**Town of Kittery  
Planning Board Meeting  
August 8, 2019**

**ITEM 1 – 76 Dennett Road – Site Preliminary Plan Review**

**Re: Response to Review Comments**  
Proposed Mixed-Use Residential  
Development Project  
76 Dennett Road, Kittery, ME 03904

**RE: Town of Kittery, Planning Board Services  
Mixed-Use Development Proposal – 76 Dennett Road Lots 6-15B, 6-16A, 13-4  
Preliminary Plan Approval Application  
Review of HTA Responses dated July 25, 2019; and  
MDOT Traffic Movement Permit Application dated July 1, 2019  
CMA #591.125**

REAR LANDSCAPING PLAN  
**C18**  
 PROJECT NO. 569200  
 SHEET 18 OF 25

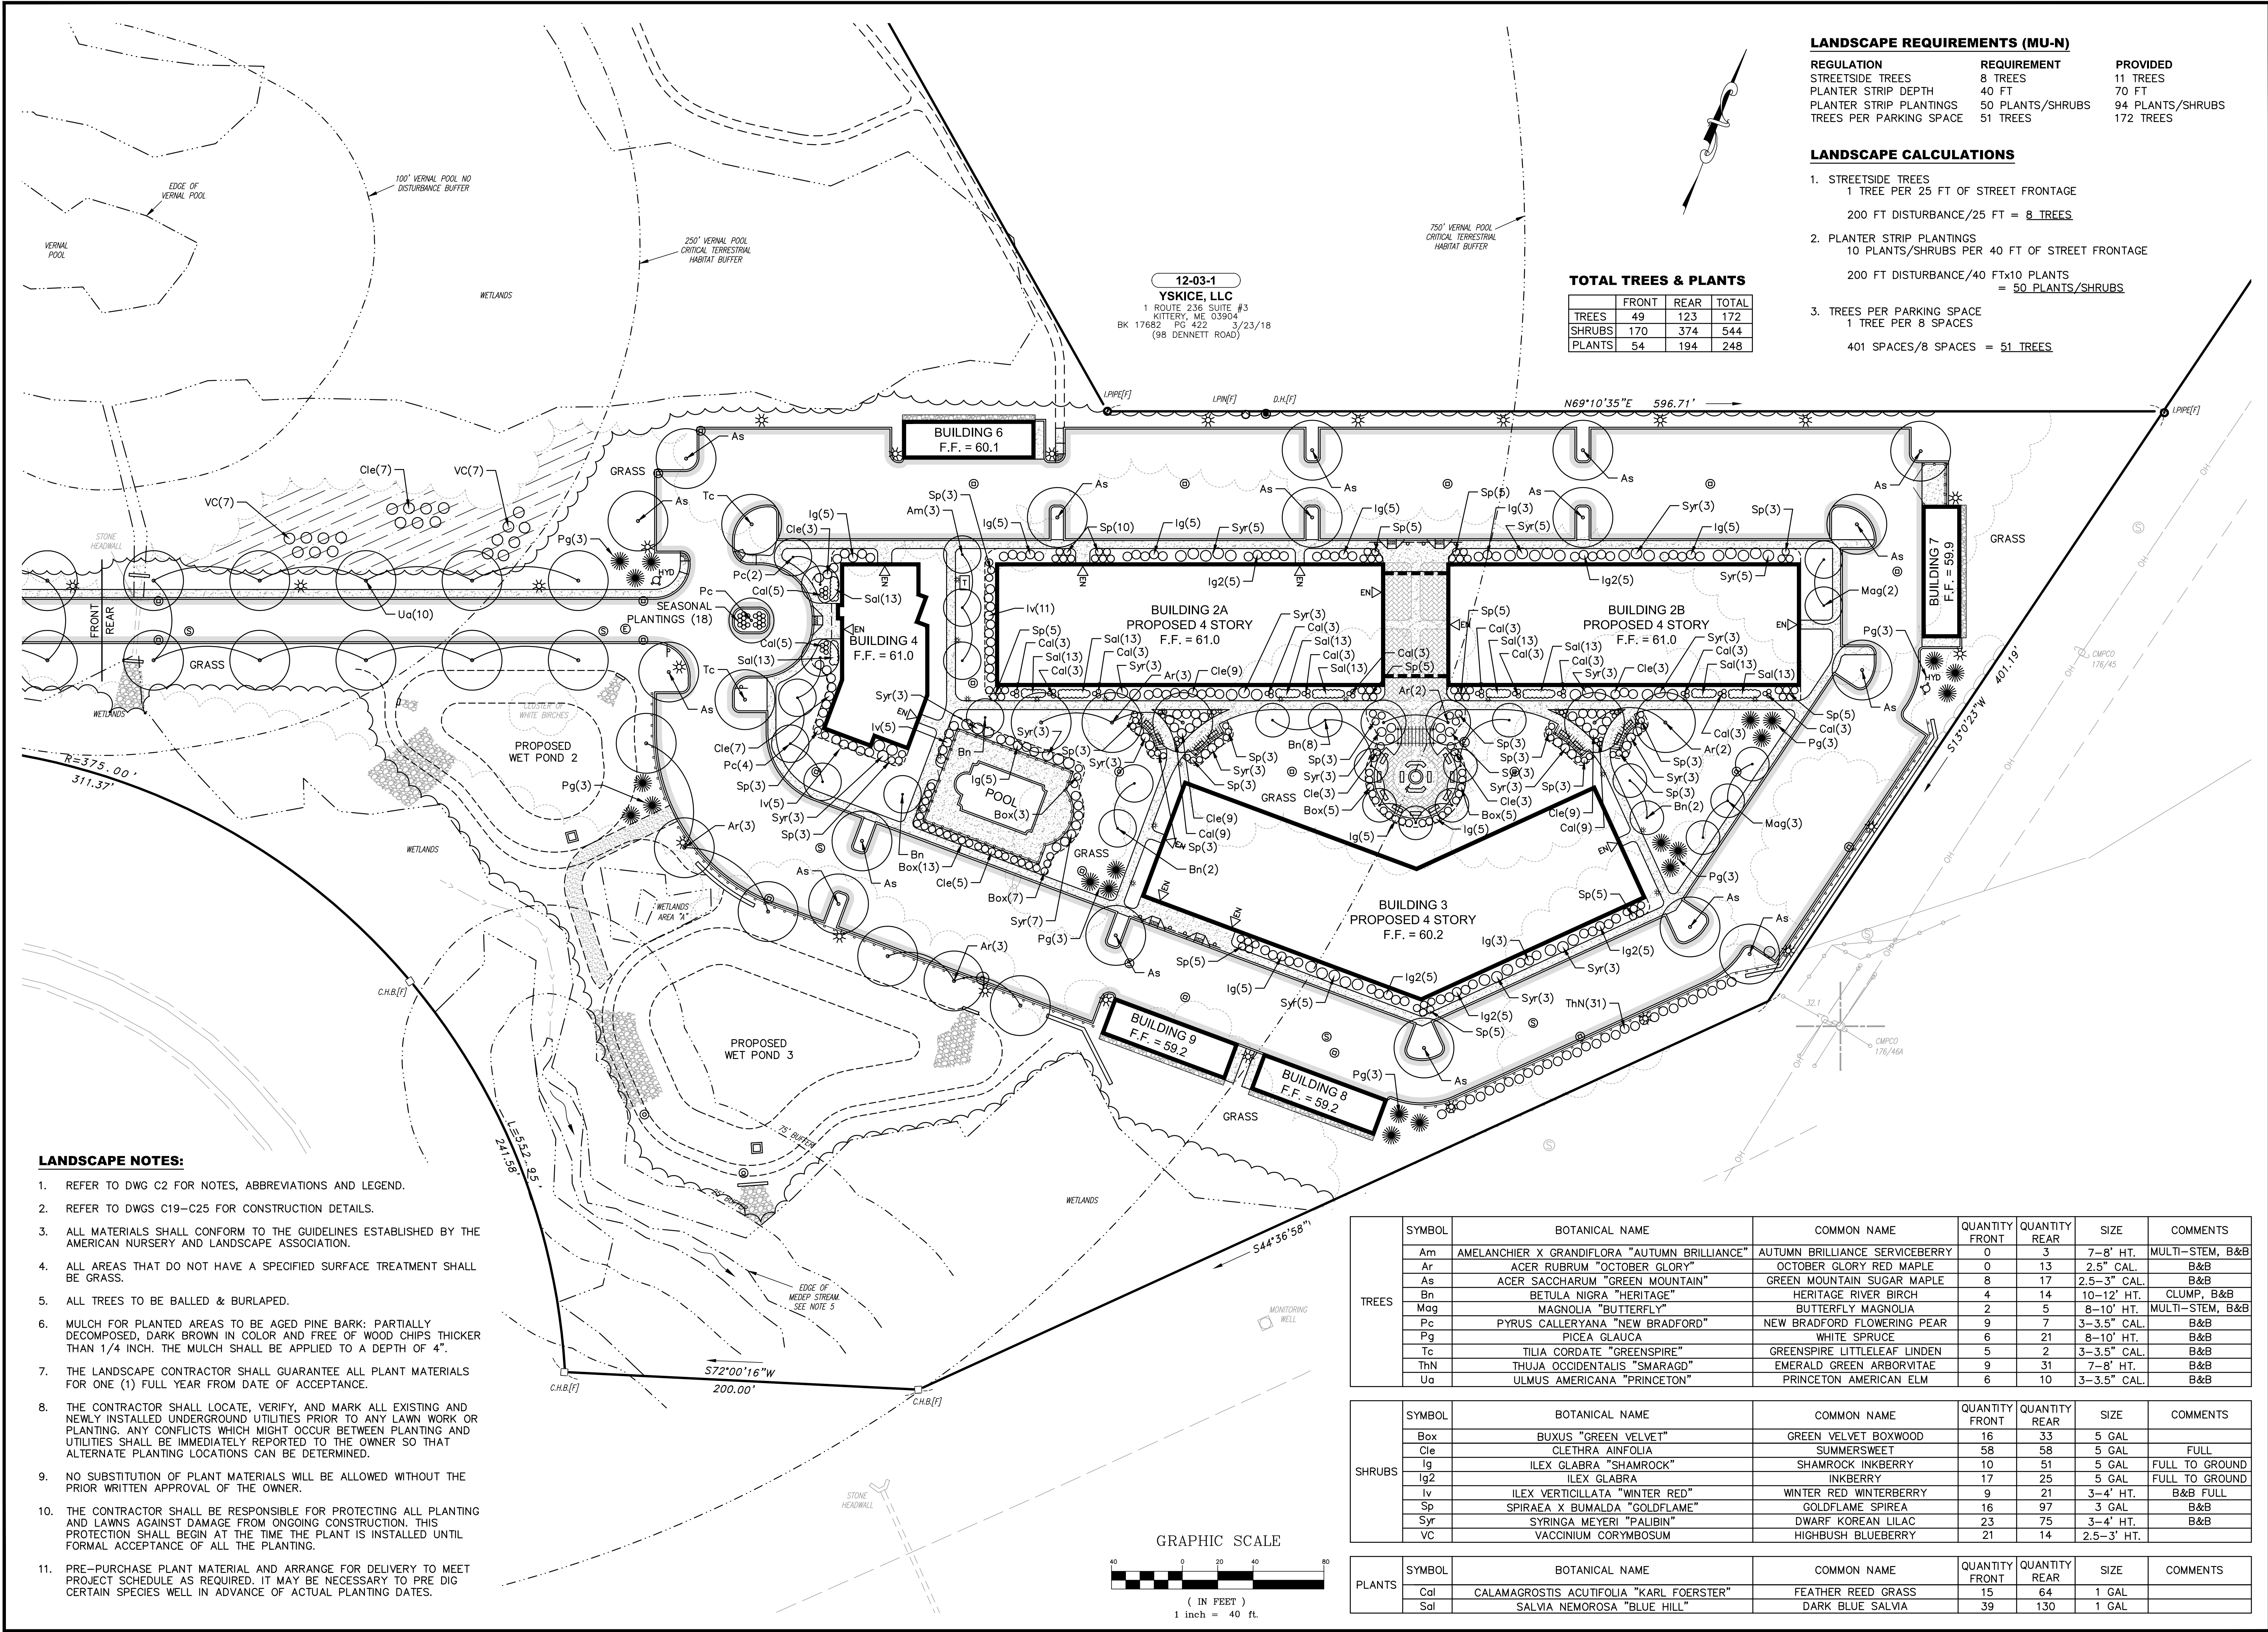
- *The landscaping plan does not appear to have been prepared by a registered landscape architect. It is detailed, with extensive plantings with multiple species. The applicant should describe how the plan was developed and the qualifications of the designer.*

The Town of Kittery regulations allow for the landscape plan to be prepared by other design professionals at the discretion of the Planning Board. Hoyle, Tanner has provided landscape design on numerous large scale projects in the seacoast area as well as the state of Maine and we feel the prepared landscape plans satisfies the requirements set forth in the Town of Kittery Land Use & Development Code. The planting list, quantity, size and layout are consistent with other developments in close proximity to the project. All species are readily available at local nurseries and are resistant to the harsh New England climate.
